Product Change Notification

1. ECR #: 208389
Notification #: 604

3. Series:
• UEC5 - UEC5

Updated dimensions from Detail A of Recommended PCB Layout

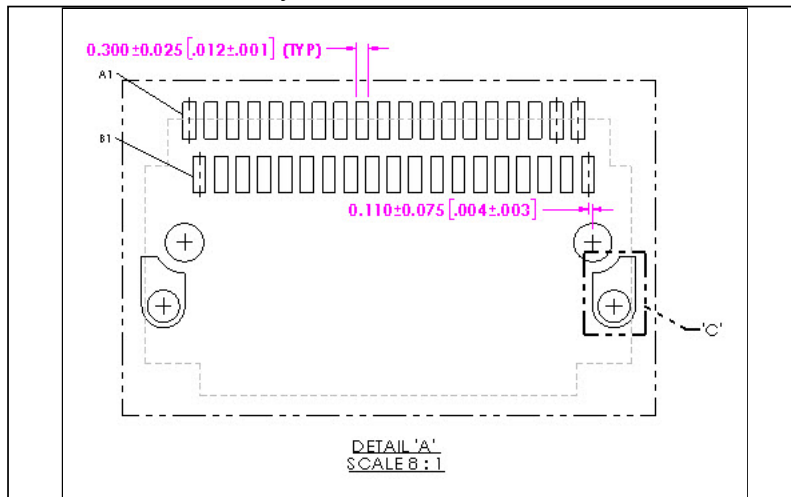
5. Description of Change:
Additional tolerances are being added for through hole to pad location and pad width. Update 0.11 to 0.110+/-0.075 and 0.30 to 0.300+/-0.025 in Detail 'A'.

The Assembly design has not been modified, this is only a change to the tolerance of 2 dimensions on the recommended PCB Layout.

7. Reason for Change:
Tighter than industry standard tolerances are required for reliable IPC-A-610 Class 2 processing.
